**ON-SCENE COORDINATOR'S REPORT
FOR INSTALLATION OF A LANDFILL
FINAL COVER FOR THE CERCLA NON-
TIME-CRITICAL REMOVAL ACTION AT
INSTALLATION RESTORATION
PROGRAM SITE 14
NAVAL BASE VENTURA COUNTY, PORT HUENEME, CA**

September 2004

**RESPONSES TO AGENCY COMMENTS ON THE
DRAFT ON-SCENE COORDINATOR'S REPORT FOR INSTALLATION OF A
LANDFILL FINAL COVER FOR THE
COMPREHENSIVE ENVIRONMENTAL RESPONSE, COMPENSATION, AND
LIABILITY ACT (CERCLA) NON-TIME-CRITICAL REMOVAL ACTION AT
INSTALLATION RESTORATION PROGRAM SITE 14
CONSTRUCTION BATTALION CENTER PORT HUENEME
NAVAL BASE VENTURA COUNTY, CALIFORNIA, MAY, 2004**

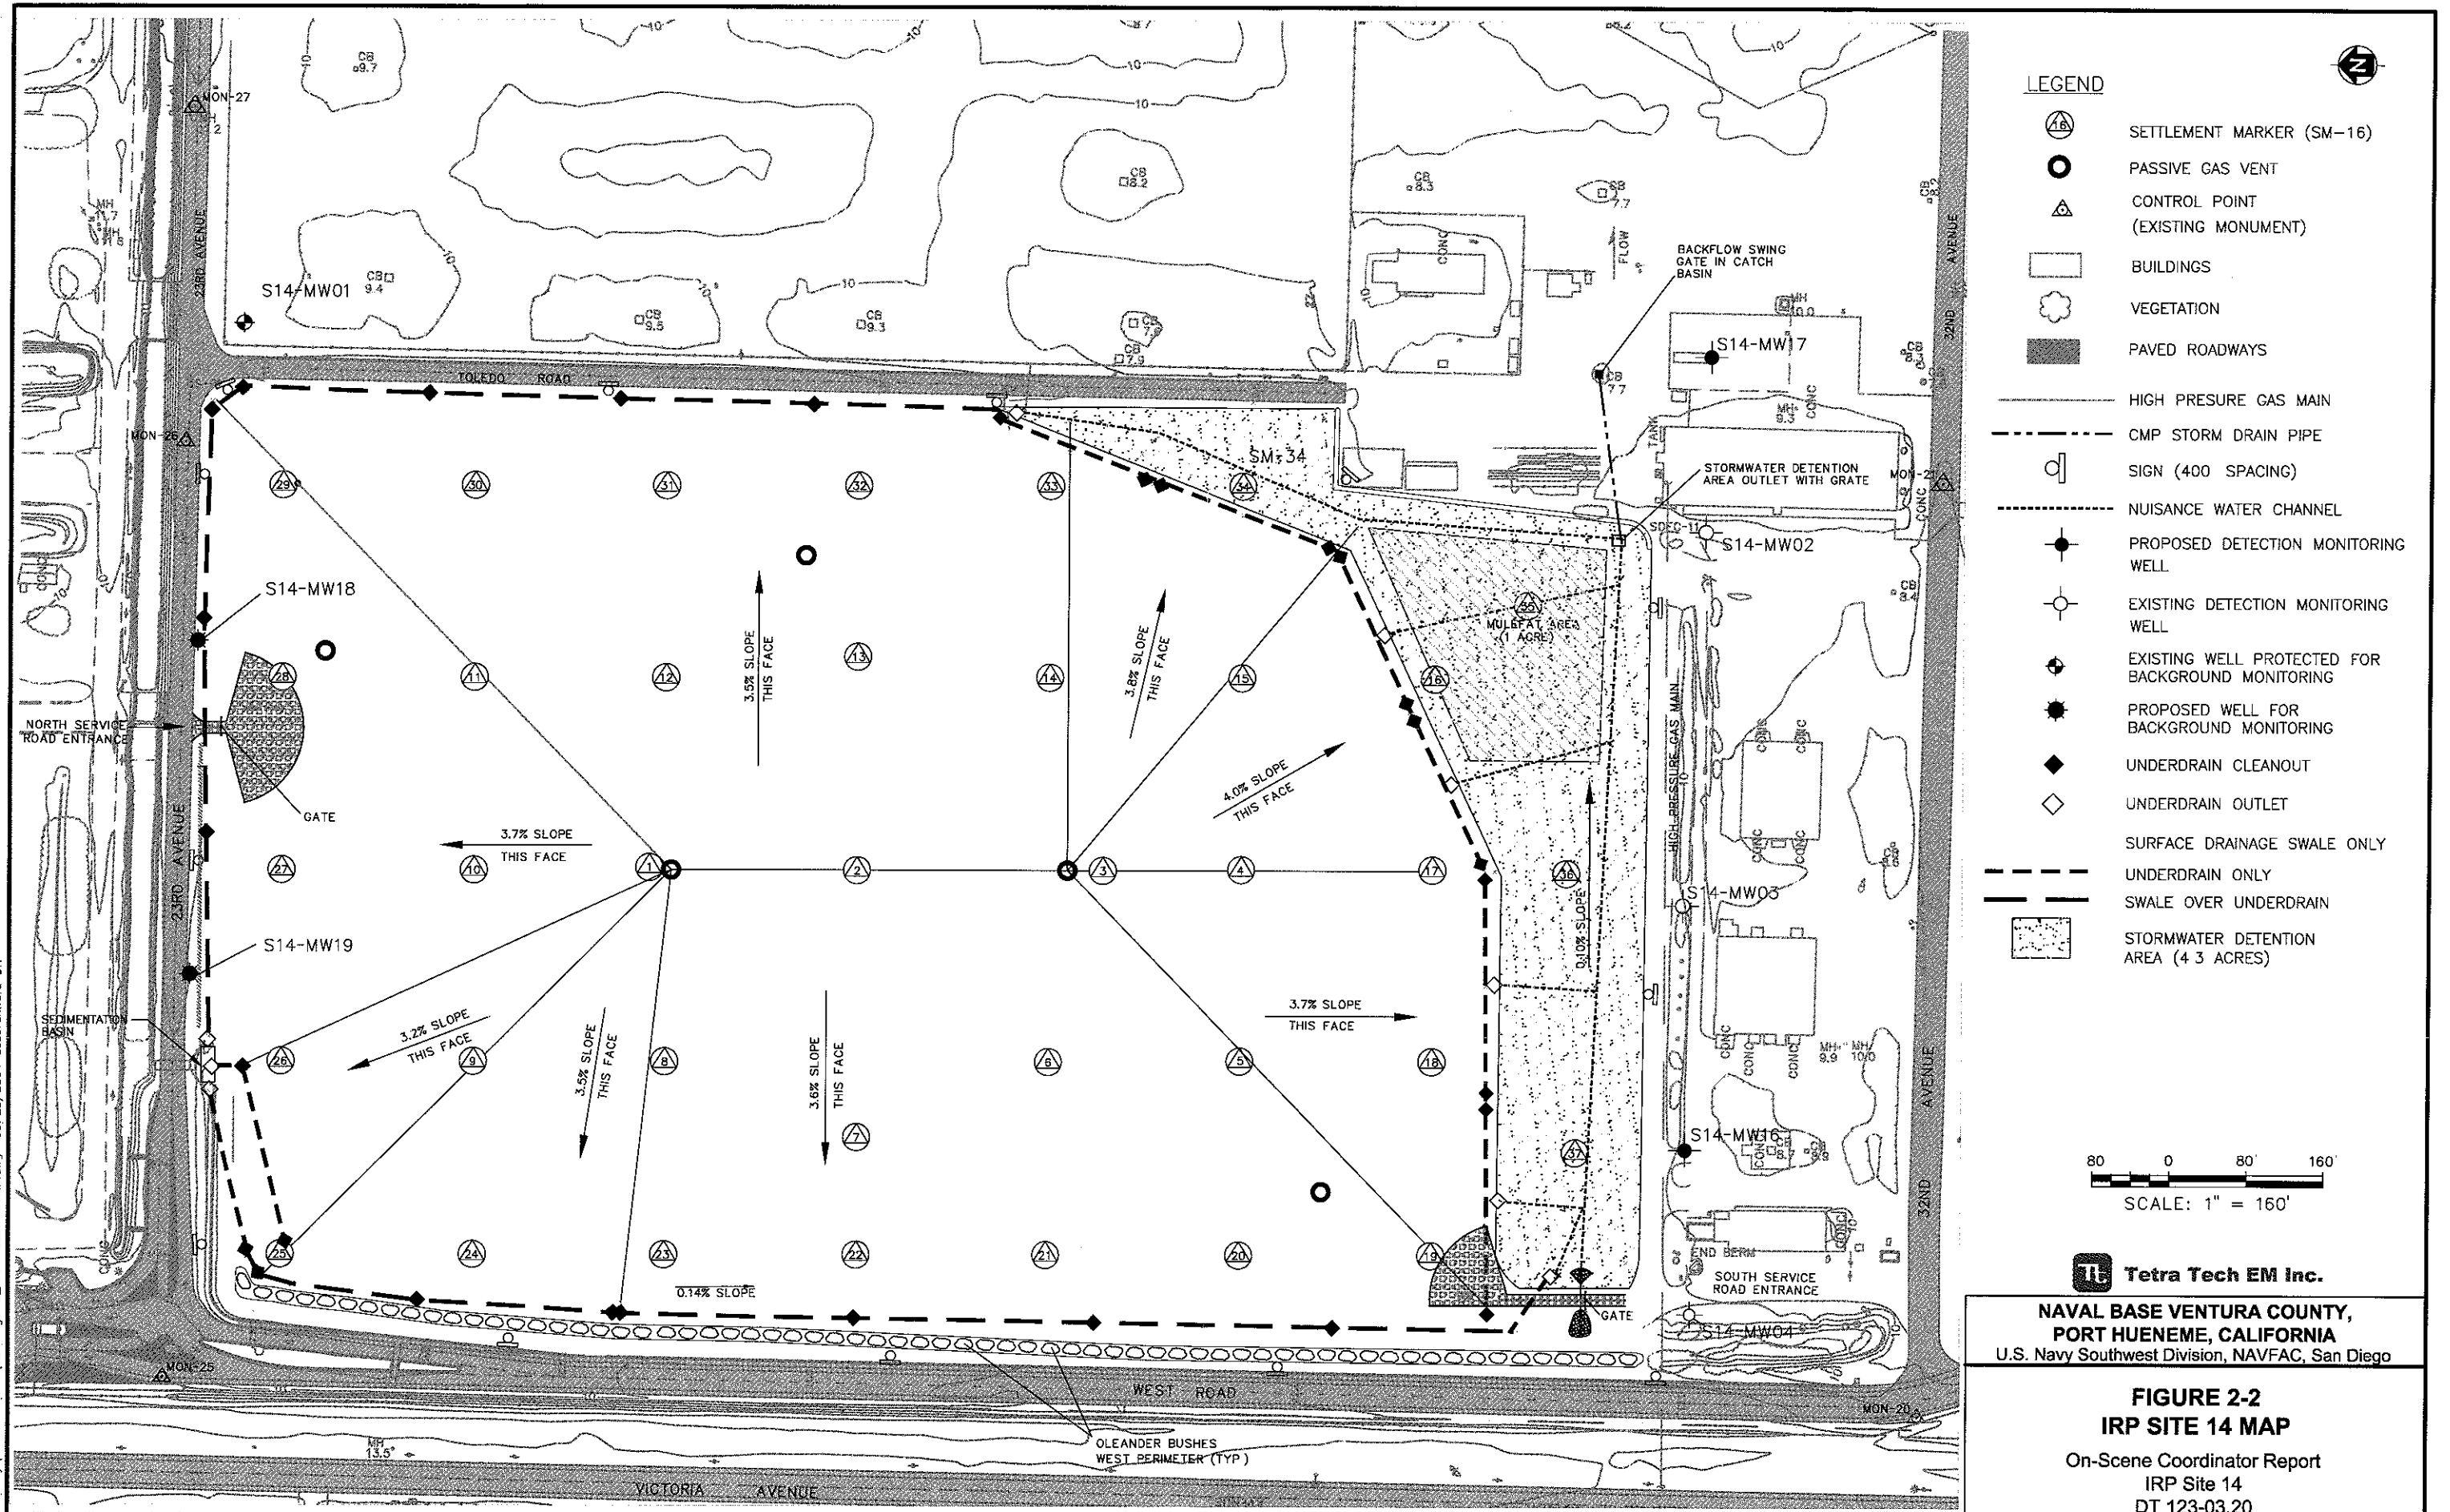
2. **Comment:** P. 12, § 4.3, Difficulties Interpreting, Complying With, or Implementing Policies and Regulations, 2nd ¶. Please add to the end of 2nd sentence to read “. . . is presented in Table 4-1 *and shown in Figure 2-2.*” (addition italicized).

Response: The italicized text will be added, as requested.

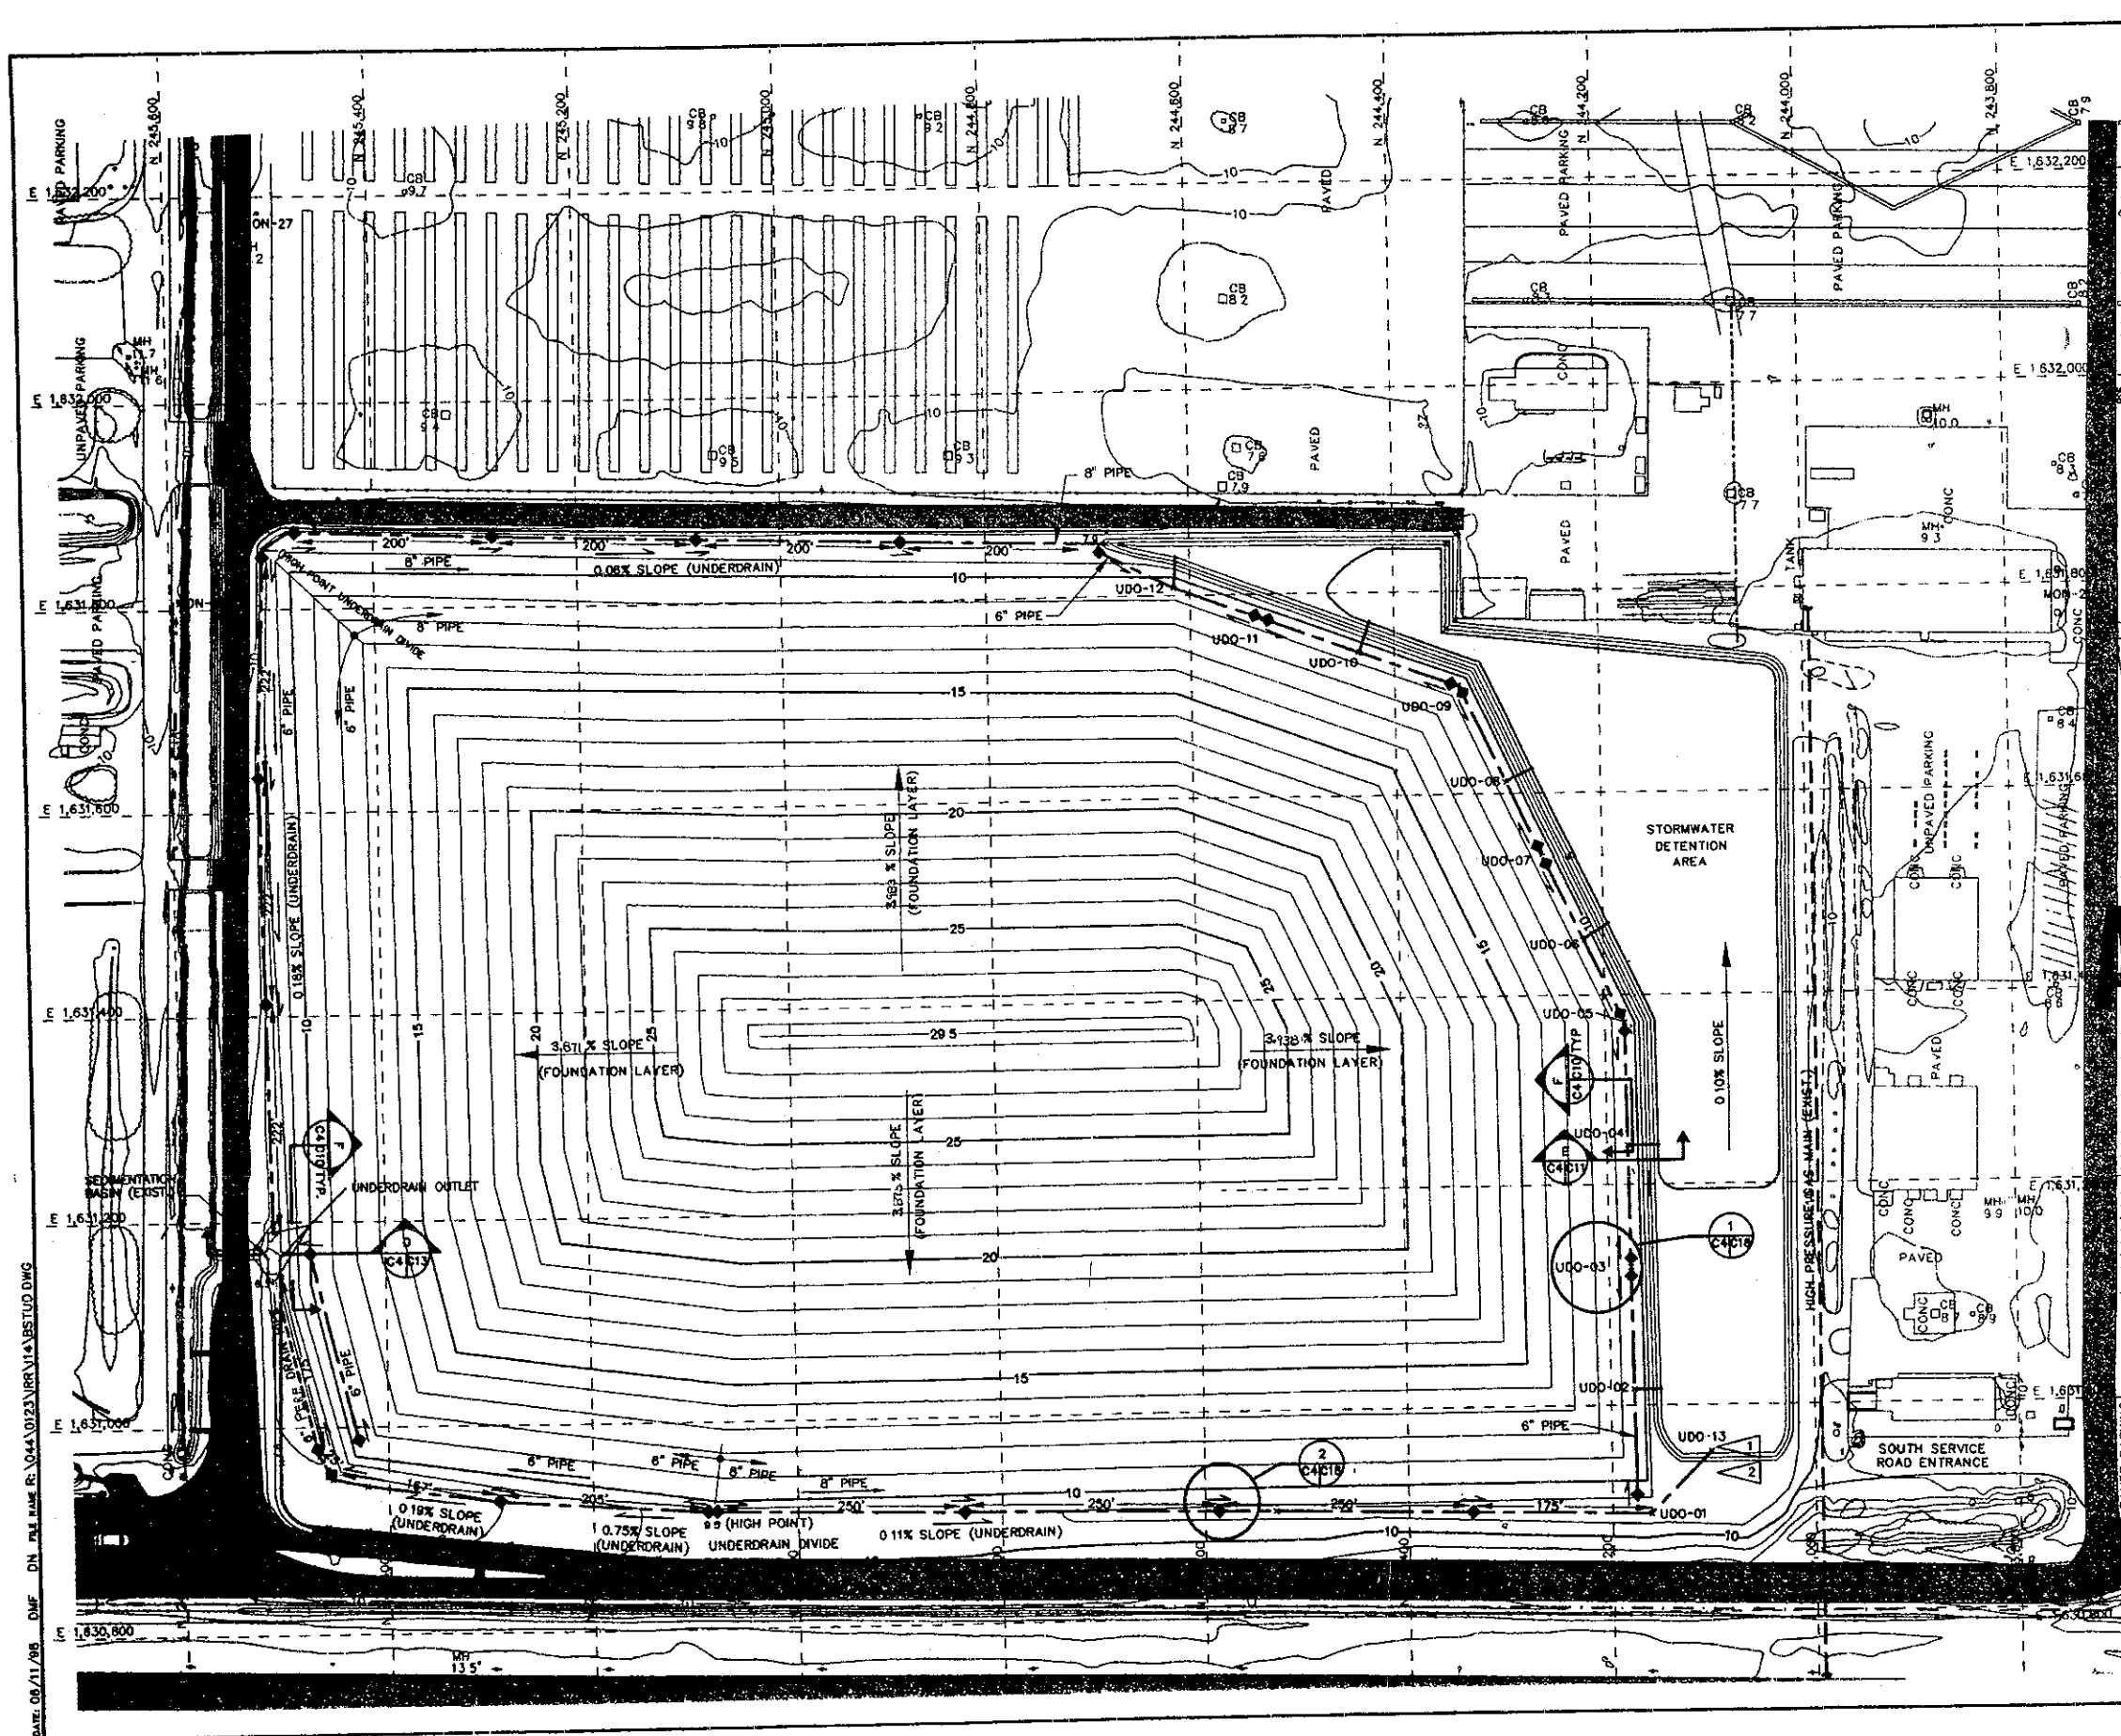
Please evaluate a dip of the 9-ft line at the NW corner. Also, the area just north of this dip appears to have migrated towards the interior, as indicated by tight contours not evident in Drawing C3.

Response: The Navy has routinely transmitted O&M reports, such as the one referenced, since the cover was completed. The OSC report is concerned only with construction activities and, therefore addresses the construction phase. The Navy will continue to generate O&M reports that will be transmitted to DTSC.
